ZONING AND PLATTING COMMISSION SITE PLAN VARIANCE REVIEW SHEET

CASE NUMBER: SP-2019-0109C **ZAP DATE:** 5/5/2020

PROJECT NAME: Water Oak Apartments

APPLICATION REQUEST: The applicant has requested a variance from LDC 25-8-341 to allow cut in excess of 4 feet on slopes exceeding 15 percent.

EXHIBIT 4

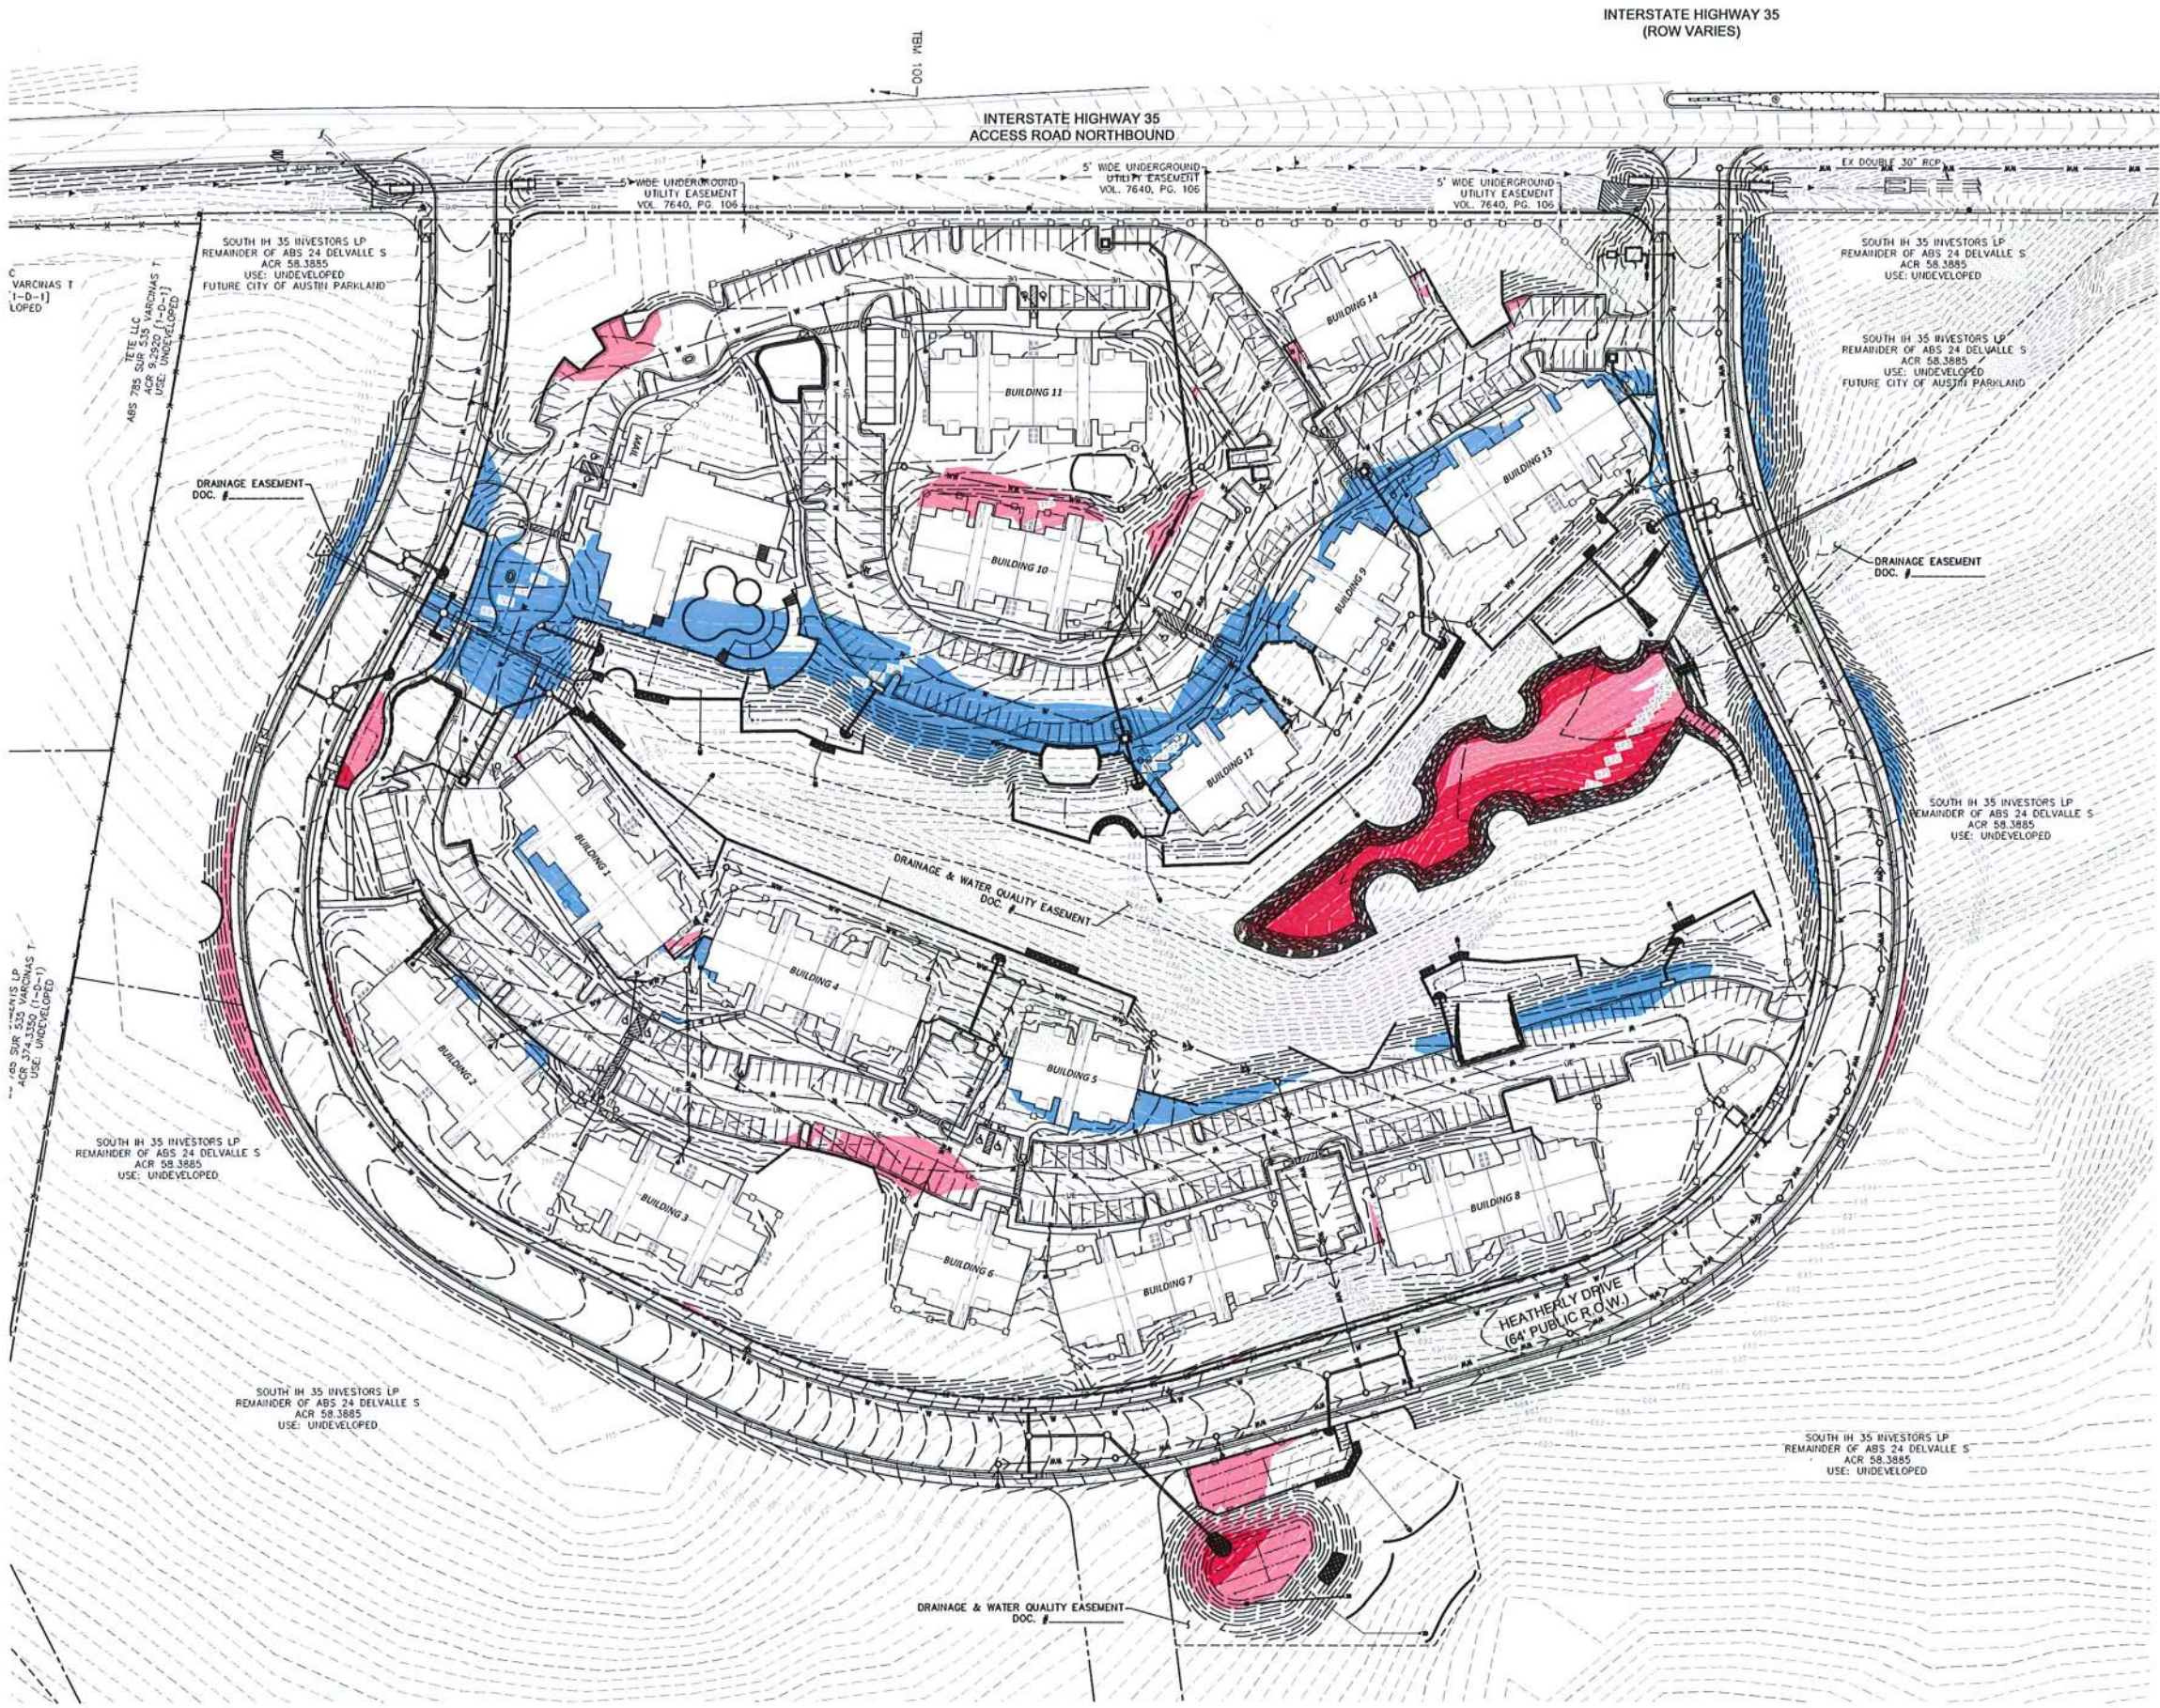
Yes The site slopes toward the middle, from east and west, toward an unclassified creek (drainage area less than 64 acres) that bisects the lot (see Applicant Exhibit 4 for topography). With a gross site area of 21.4 acres, 1.6 acres have slopes between 15 and 25 percent, 0.5 acres have slopes from 25 to 35 percent, and 0.04 acres have slopes over 35 percent. The steepest slopes are at the north, downstream end of the creek. This is also the best location for the detention pond, since it is the lowest point of the site.
